RECORD OF TELEPHONE CONVERSATION

DATE: March 26, 1982 8:30 am to 11:30 am PROJECT: Midland
RECORDED BY: Joseph Kane CLIENT: _____
TALKED WITH: CPC Bechtel COE GEI NRC
T. Thiruvengadam J. Anderson H. Singh S. Poulos J. Kane
K. Razdan L. McKelvey
R. Ramanujam C. Russell
W. Paris
S. Afifi
N. Swanberg

MIDLAND PROJECT
DOCKET NOS 50-329, 50-330
SOILS SETTLEMENT REMEDIAL ACTION
FOR THE SERVICE WATER PUMP STRUCTURE (SWPS)
FILE: 0485.16, B3.0.8 SERIAL: 13738
REFERENCES: JWCOOK TO HRDENTON, SERIAL 11625 DATED MARCH 23, 1981.
ENCLOSURES: MIDLAND UNITS 1 AND 2 - TECHNICAL REPORT
ON UNDERPINNING THE SERVICE WATER PUMP STRUCTURE.

TECHNICAL REPORT ON UNDERPINNING
THE SERVICE WATER PUMP STRUCTURE
FOR
MIDLAND PLANT UNITS 1 AND 2
CONSUMERS POWER COMPANY
DOCKET NUMBERS 50-329 AND 50-330

Figure 3

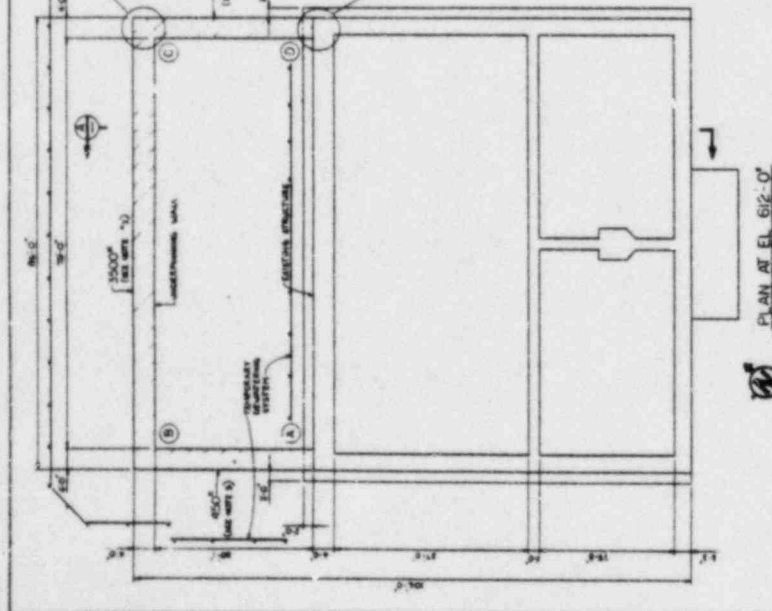
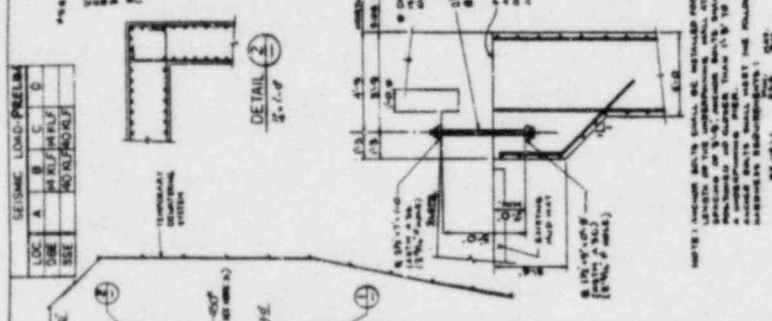
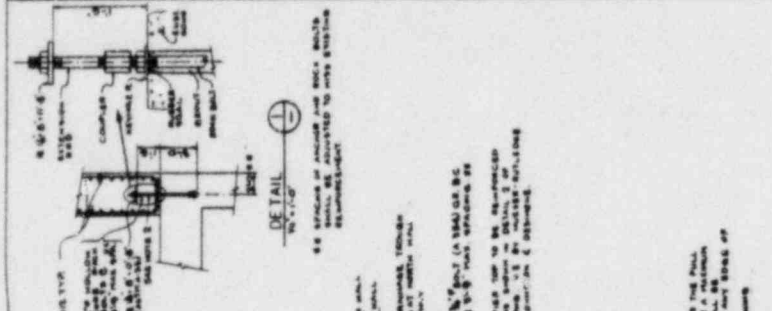
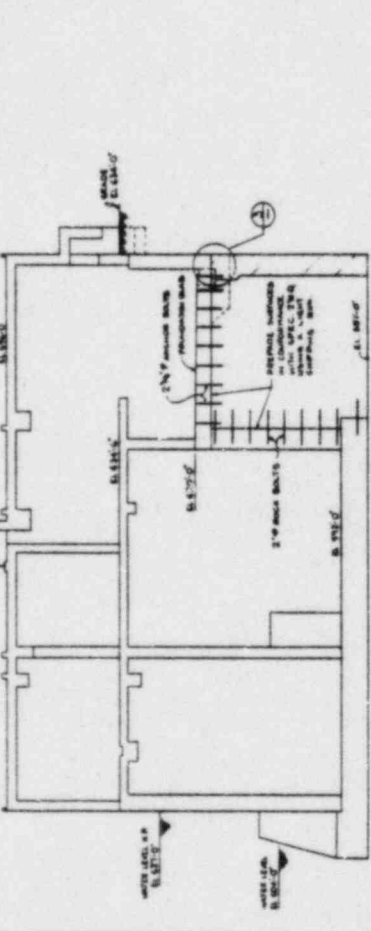
what established the proper point

how established

how established
